CITY OF TAYLOR, TEXAS

PLANNING AND ZONING COMMISSION MEETING

March 8, 2022, 6:00 P.M.

**Castlewood Subdivision
Phases 2 & 3 Final Plat
530 FM 973
Approximately 26.18 Acres**

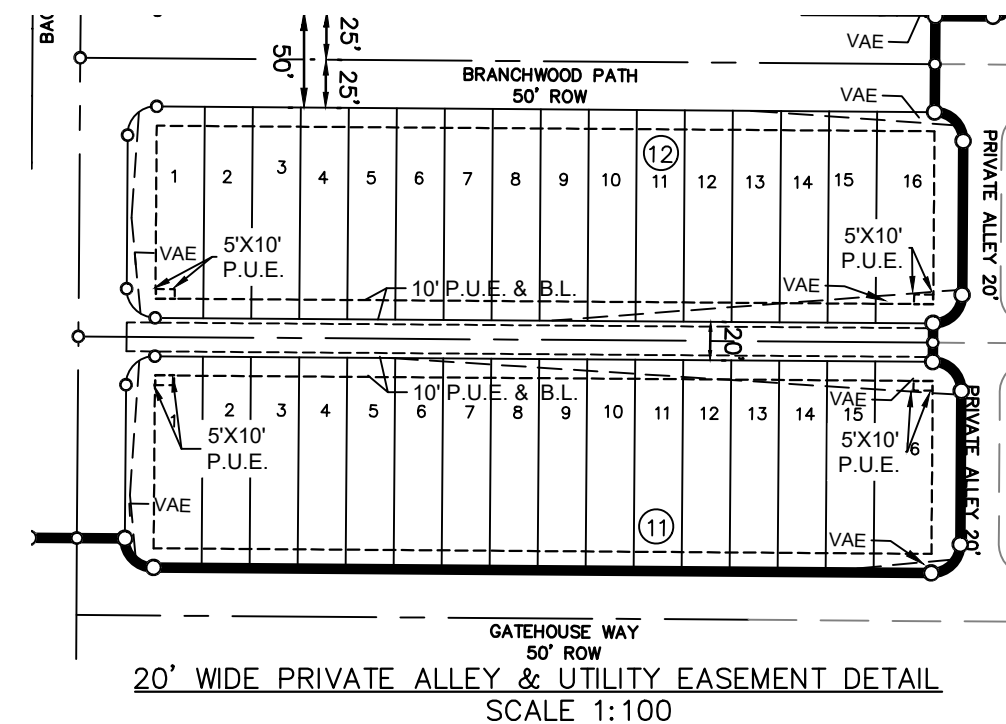
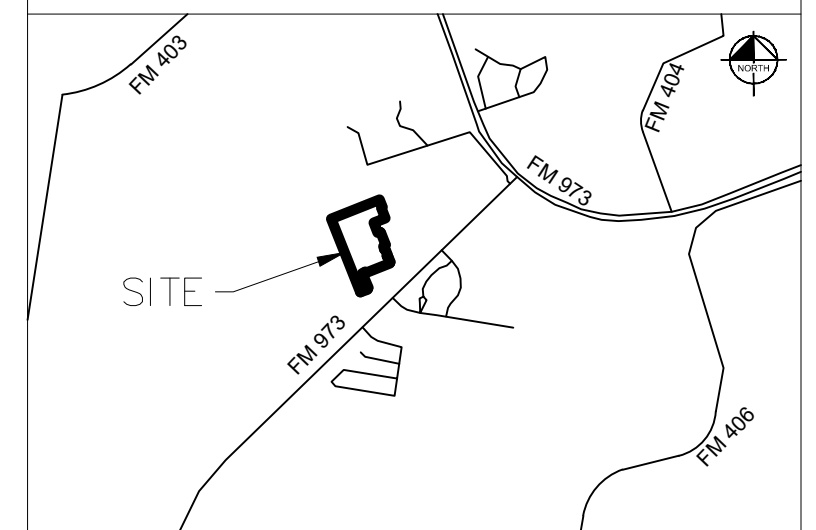
Remove the note at the top of Sheet 1. It's about 18 lots. There are already 18 lots.

- Items noted on the plat review drawing (engineering review) do not match metes and bounds. Verify and revise items, total of 3 items noted.

ALLEY DETAIL
TOWNHOME BUILDING SETBACKS (B.L.) &
PUBLIC UTILITY EASEMENTS (P.U.E.)
-TOWNHOME BLOCKS 11 & 12

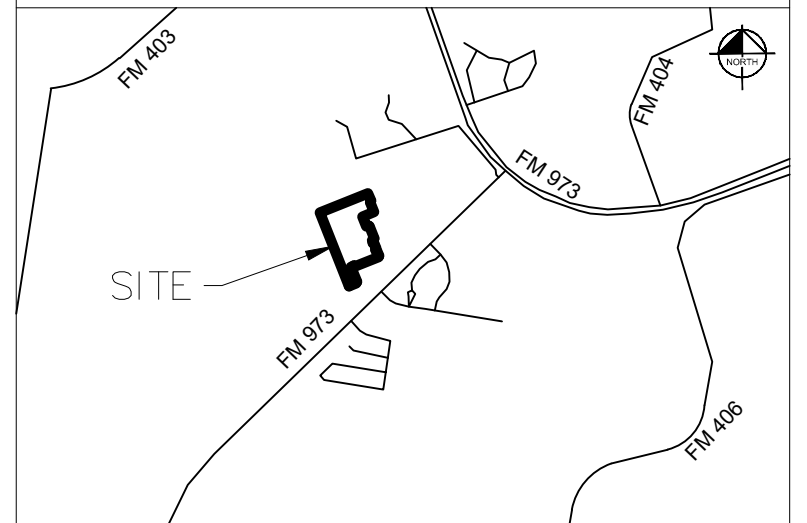
Refer to the Planned Development Ordinance in the Plan Review Uploads, Development Standards so you can get the Twin Home Detail correct. Also, it's labeled Townhome in Detail "D" which is not correct. Remove 2.5' PUE. Refer to the Development Standards Table in the Planned Development Ordinance for the setbacks when the dwelling units are not attached.

Remove the interior side yard setback from the Townhomes Detail. There's only a 5-foot setback when the townhomes are not attached. Might only be the end of 16, might 4 or 5...

Correct the Line Type Legend on Sheet 2.

Show all the Blocks in the Tables, Sheet 2.

- Provide center line information (distance, bearings) on the plat as provided in Castlewood Phase 1.
- Revise the area for the match line Sheet 1 to show all text in grayscale. Portions of text and some linework are shown as bold.
